MAXWELL PROJECT

SUBMISSIONS REPORT

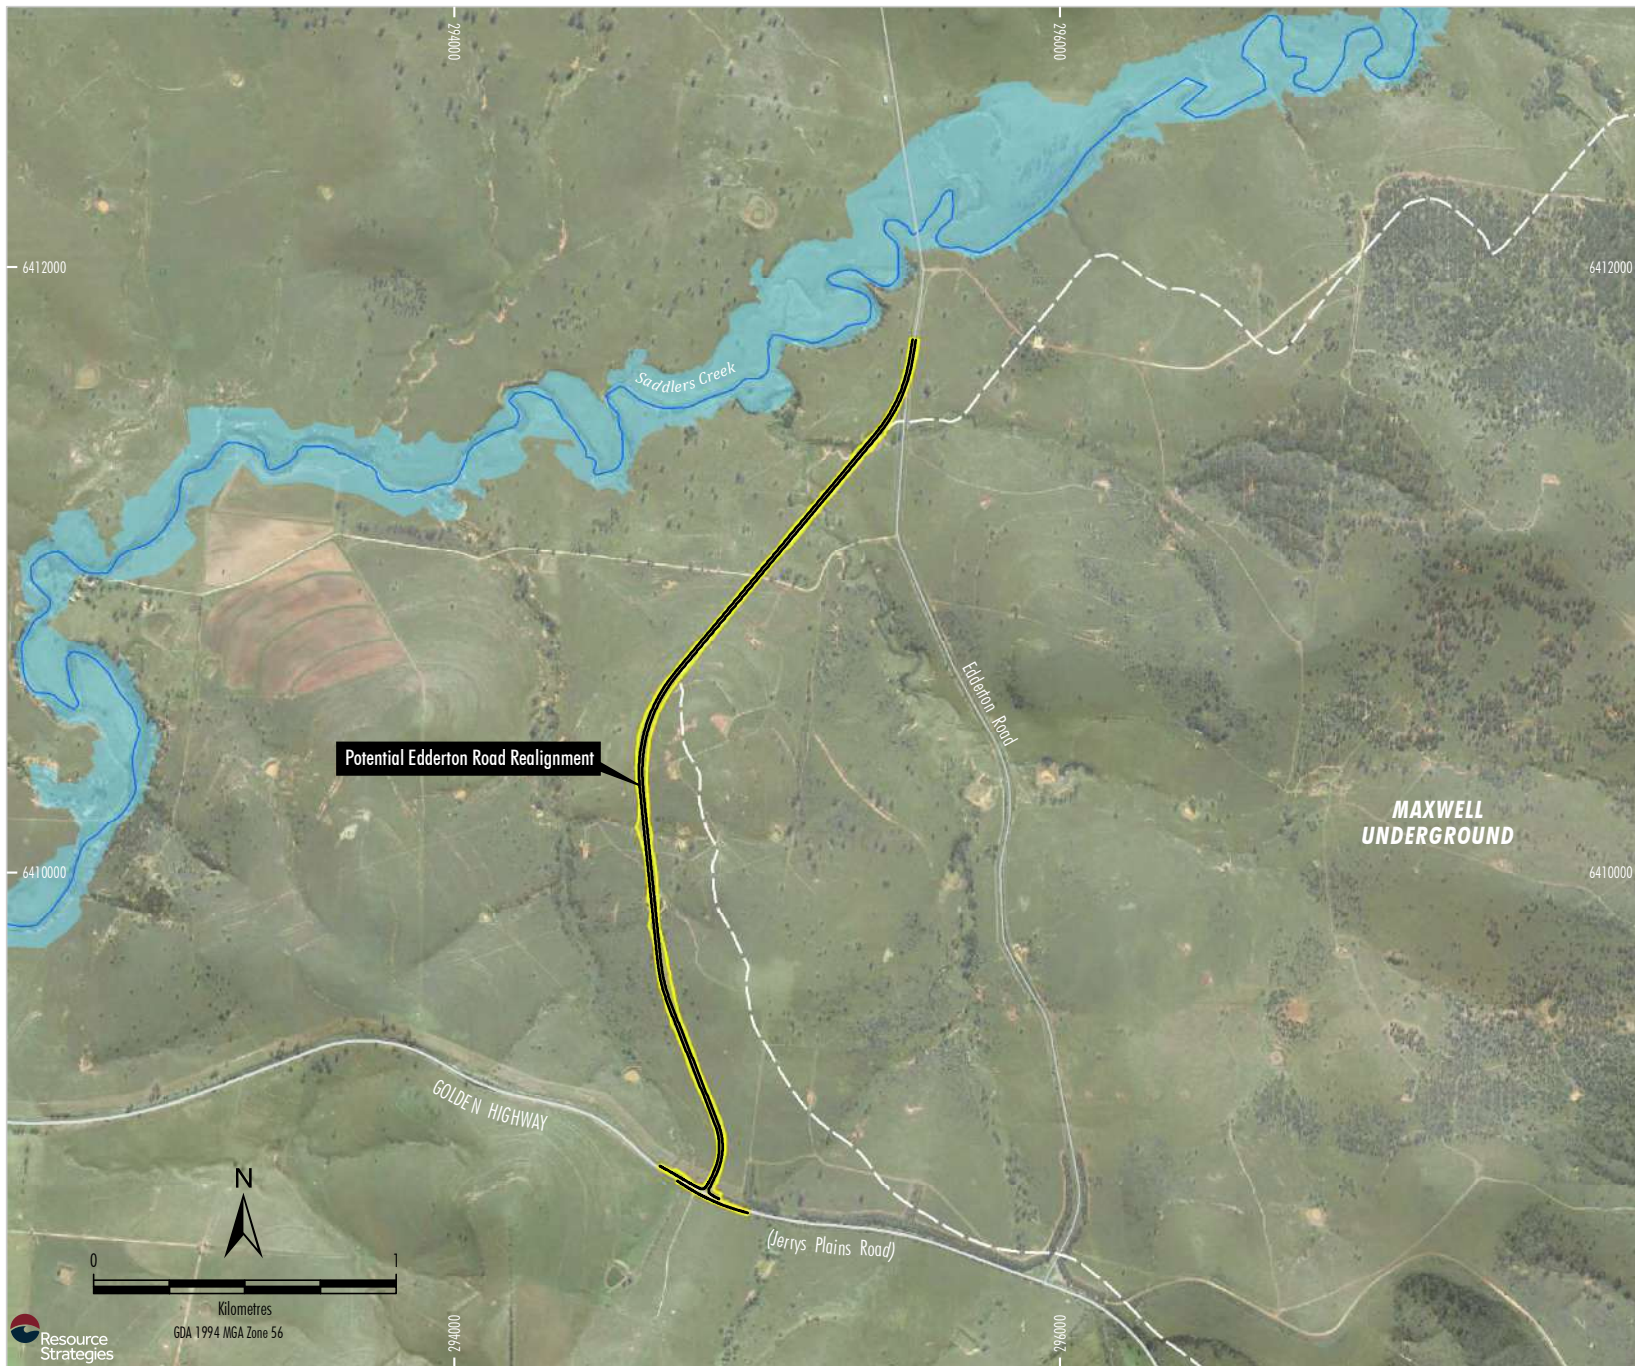
MSC recommended that the Development Consent for the Project include a requirement for a financial contribution to the upgrade of the Bimbadeen Road and New England Highway intersection to enable residential subdivisions that will utilise Bimbadeen Road.

Malabar has undertaken negotiations to make an annual Community Contribution under a Voluntary Planning Agreement (Section 6.1.9) with the MSC. If the committee established to make recommendations on the distribution of the annual Community Contribution supports funding of an upgrade of the Bimbadeen Road and New England Highway intersection Malabar would not object to this use of the funds.

Figure 1: Location of Receptor 389 and receptors assessed in detail

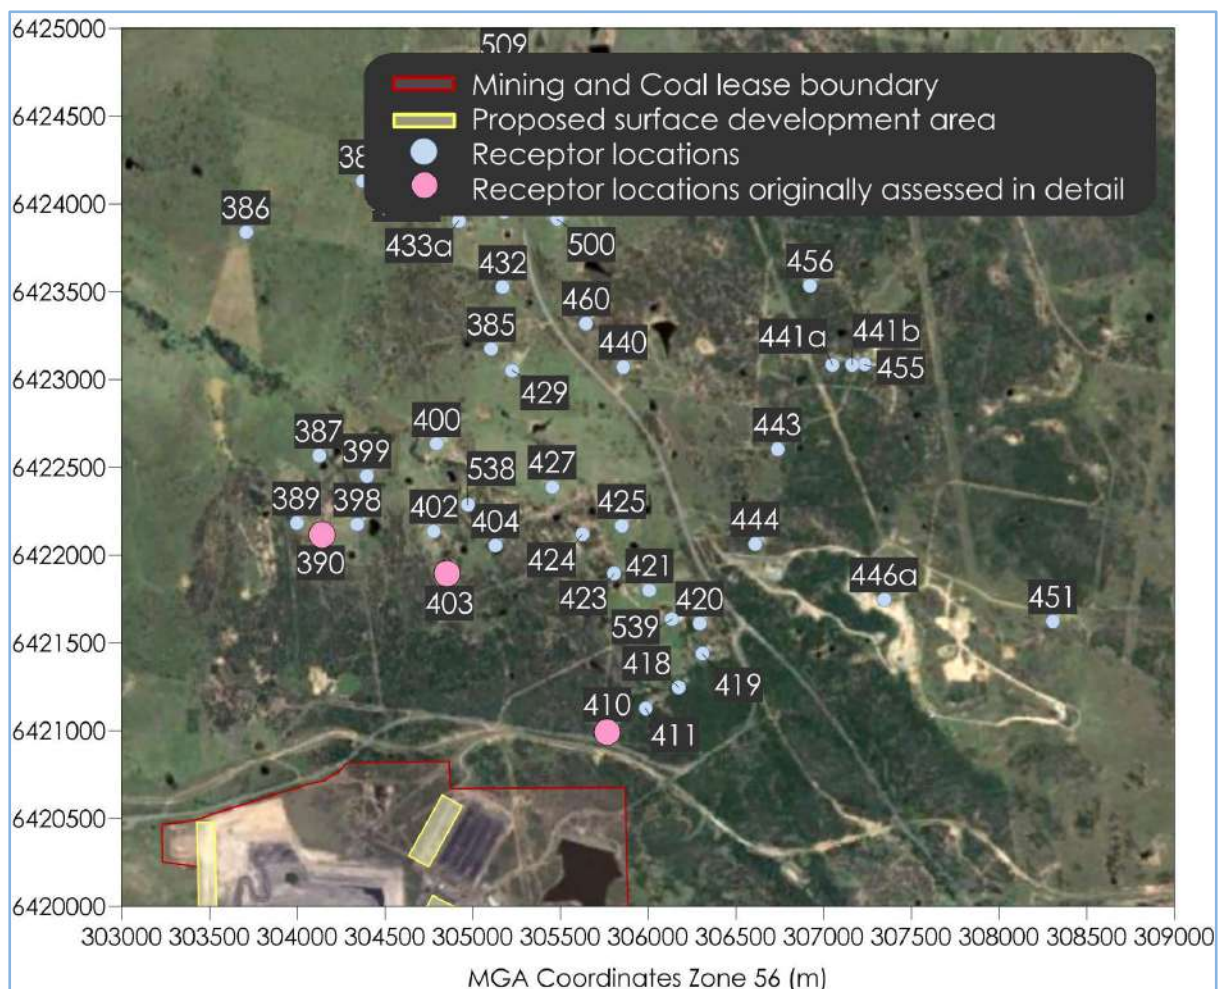
The EPA also requested further detail on the cumulative 24-hour results for Receptor 389 (mine-owned receptor), which was predicted to have the highest Project increments in some cases. The locations of the closest receptors to the Maxwell Infrastructure, which were assessed in detail in the AQIA, are set out in **Figure 1**, along with the location of all other receptors in proximity to the Maxwell Infrastructure, including Receptor 389.

The EPA is correct that Receptor 389 has higher dust levels predicted in some cases than one of the receptors assessed in detail - Receptor 390. Privately-owned Receptor 390 is closer to the Maxwell Infrastructure than mine-owned Receptor 389 and was therefore expected to experience greater Project increments (note receptors were selected for the 24-hour average cumulative assessment prior to results of the dispersion modelling being available).

Figure 3 Low-Frequency Spectra at Representative Receivers - Year 4

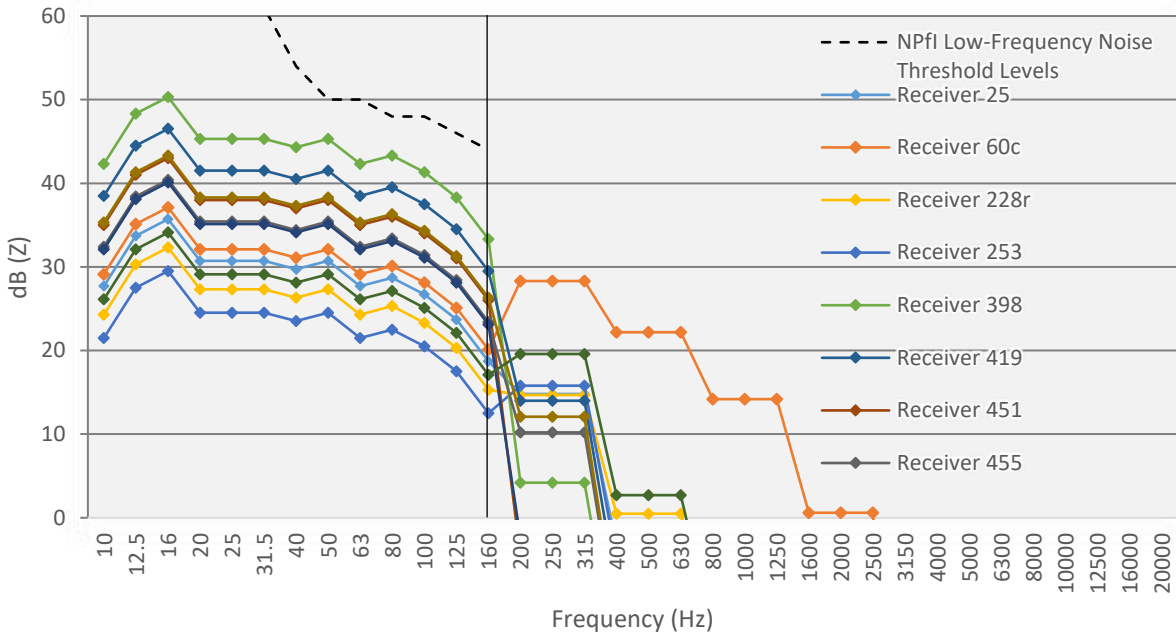
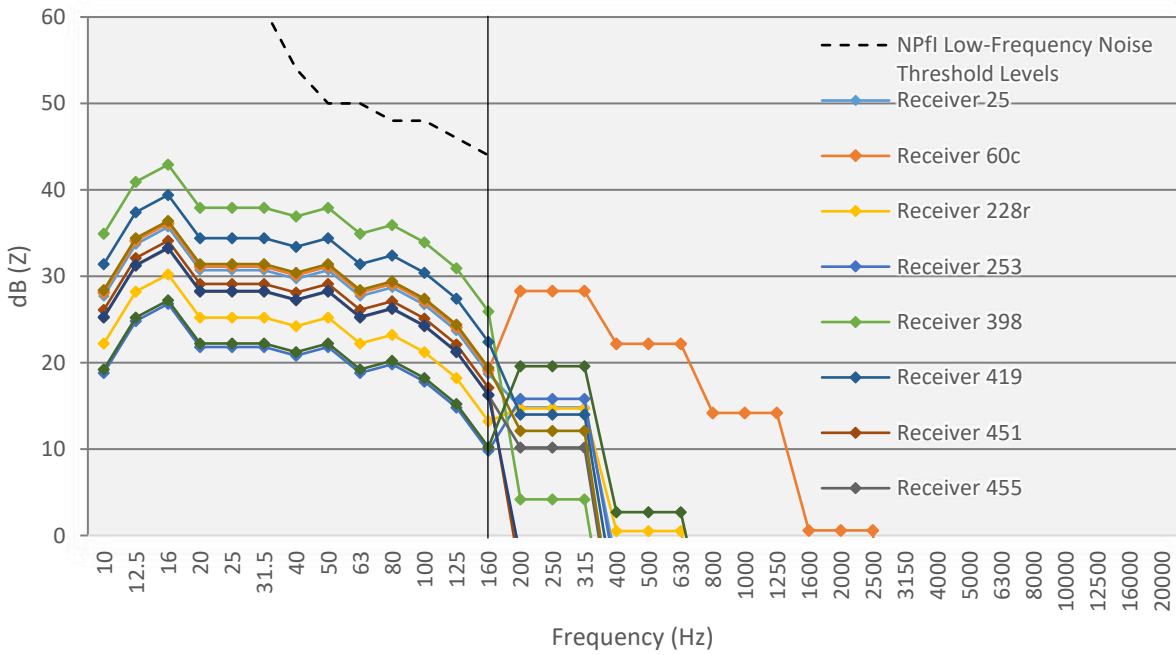
The EPA requested further information on the low-frequency noise assessment and a detailed explanation on the normalising process in relation to low-frequency noise correction undertaken.

The low-frequency noise curves, based on data gathered from an audit undertaken for another Hunter Valley mine (Figures 1, 2 and 3 of Attachment 4), show that no privately-owned receiver is expected to experience dominant low-frequency noise.
